11-E-24-HZ
APPLICATION FOR CERTIFICATE OF APPROPRIATENESS

217 E. Scott Ave. 37917
Old North Knoxville H

Modification of previously-issued COA (3-E-24-HZ), related to the siding. Revised application proposes to use smooth, 4" exposure, fiber cement siding instead of using wood lap siding to replace deteriorated wood siding.

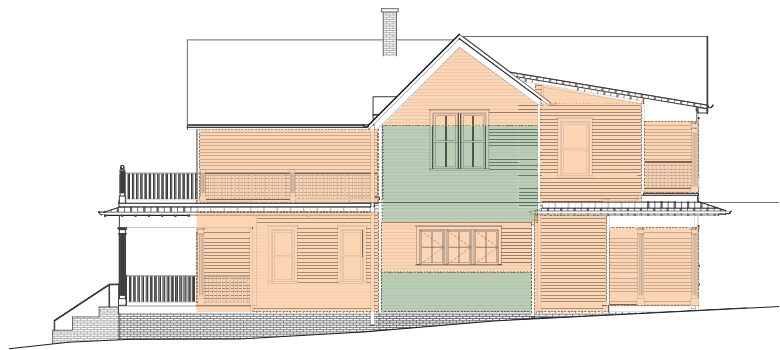
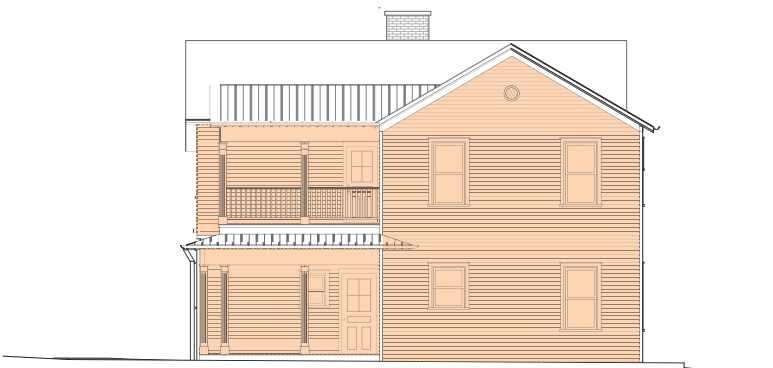
Estimated area of salvageable existing wood siding = 425 SF

Estimated area of new siding = 2950 SF
